Architectural Review Board Agenda
4:00 PM Wednesday, JUNE 5, 2024
Sussex Civic Center – Committee Room Second Floor

TO: Architectural Review Board
FROM: Gabriel Gilbertson, Community Development Director
RE: June 5, 2024 Architectural Review Board
DATE: Friday, May 31, 2024

- I. **Roll call.**
- II. **Consideration and possible action on the ARB minutes of April 3, 2024.**
- III. **Discussion and possible action on site plan, landscape plan, architecture plan, and lighting plan for Highlands Business Park Site XII.**

IV. Consideration and possible action on the site plan, architectural plan, lighting plan, landscape plan for Club Carwash located at W248N5221 Executive Dr in the B-3 Highway Business Zoning District.

SUSSEX HIGHLANDS SITE XII
HIGHLANDS COURT
SUSSEX, WI
OVERALL LANDSCAPE PLAN

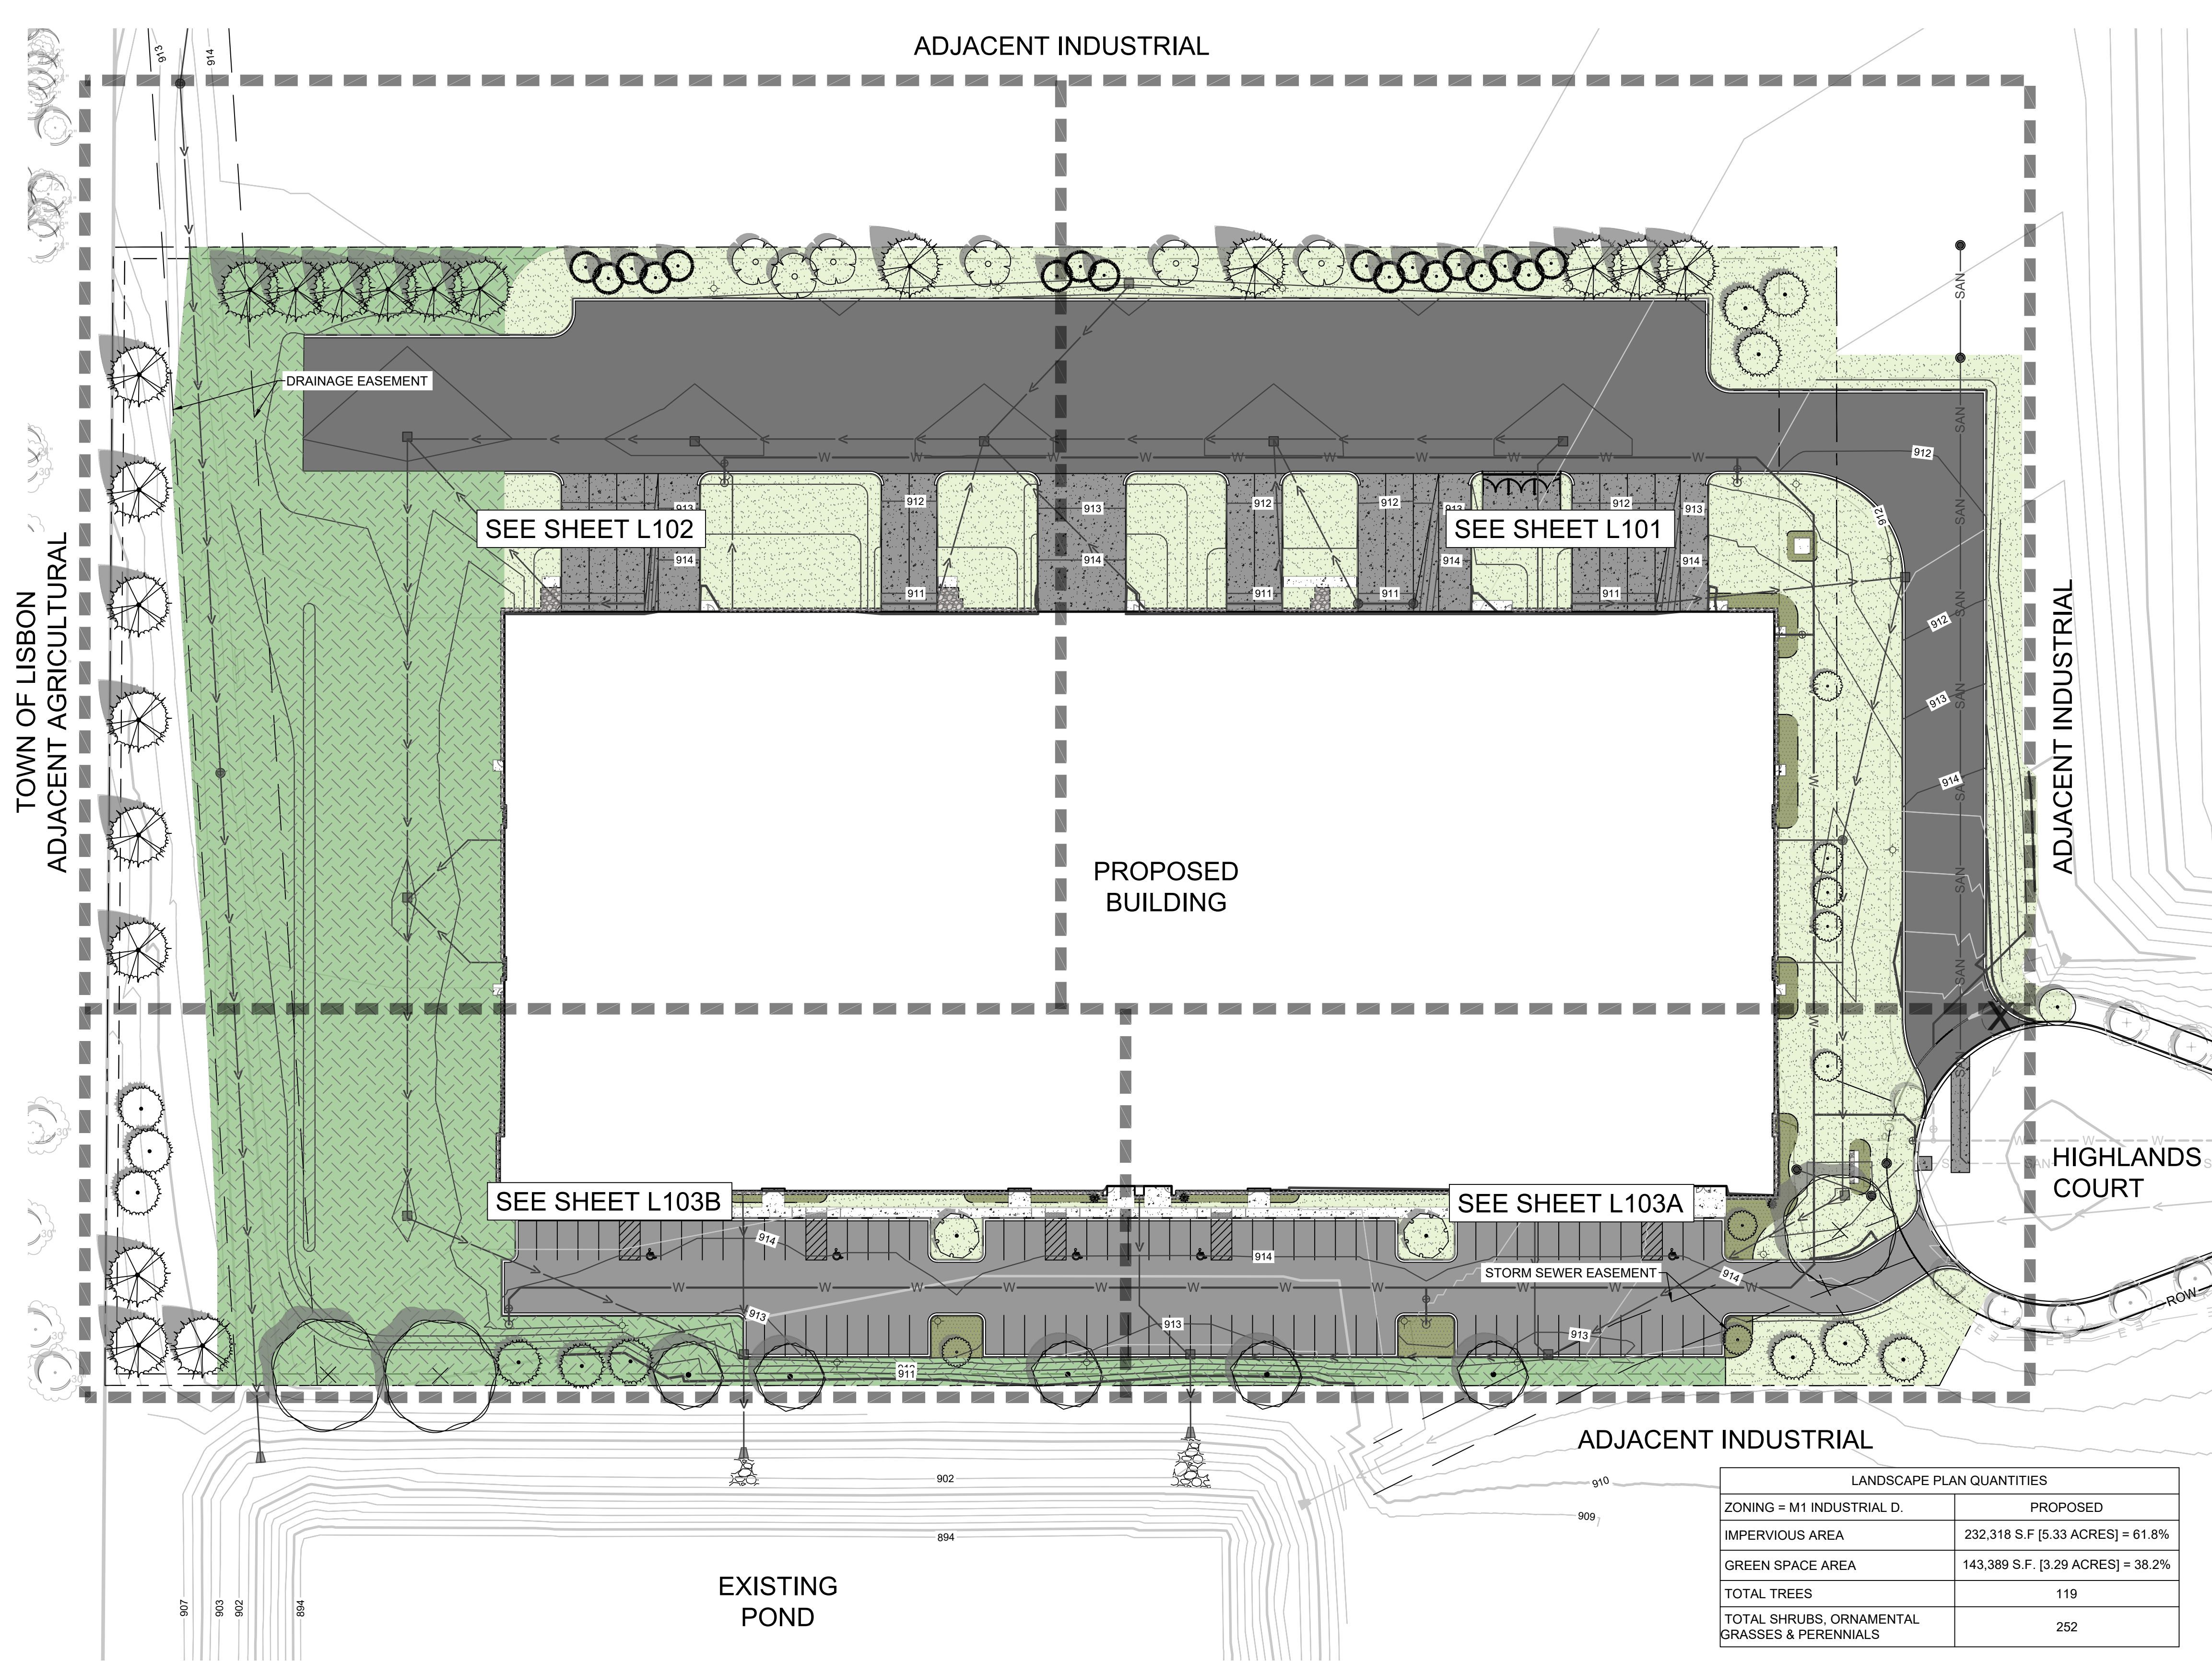
- The site has 119 trees, when 64 are required. The site has 250 shrubs, when 320 are required. The plan meets the requirements of the design guidelines for trees, but additional shrubs are required.

1. Submit revised plans for the dumpster enclosure that meet the requirements of the design guidelines to Staff for review.
2. Submit revised landscape plan that meets the minimum shrub requirements to Staff for review.
3. Submit details on how the proposed light poles will be installed for Staff to review.
4. Include a note on the elevations that with the percentage of window/door openings for each elevation to Staff for review.
